**TSI-04-12-05**

**Subject:** Clutch Damper Interference with Flywheel Bolts on Caterpillar 3406E, C-15, C-16 Engines

TMIB-0140

## Topic: Interference between the Clutch Damper and Flywheel Bolts on Caterpillar Engines

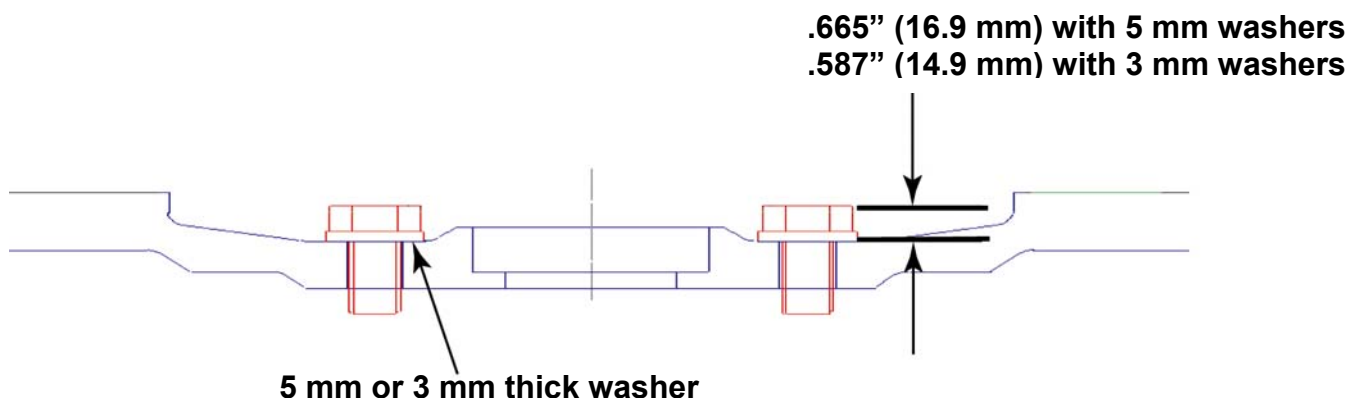
Caterpillar 3406E, C-15, C-16 built or serviced with the VCTplus clutch damper, introduced in April 2003, have the possibility of the clutch damper interfering with the flywheel mounting bolts.

Any repair that has required the transmission to be removed from the truck and the engine serial number is 5EK1 and up, 6TS1 and up, 1LW1 and up, 2WS1 and up, 6NZ1- 92122, 7CZ1 – 04382, MBN1 – 21447, BXS1 – 00984, 5DS1 and up, or 1MM1 and up, you must verify the 5mm washer has been replaced with the 3mm washer, Caterpillar part number 8D-5054. Failure to replace the washers could result in damper rivet interference. Torque the bolts to 270 Nm +/- 40Nm (200lb. ft. +/- 30 lb. ft.) and apply paint to bolt heads for completion identification.
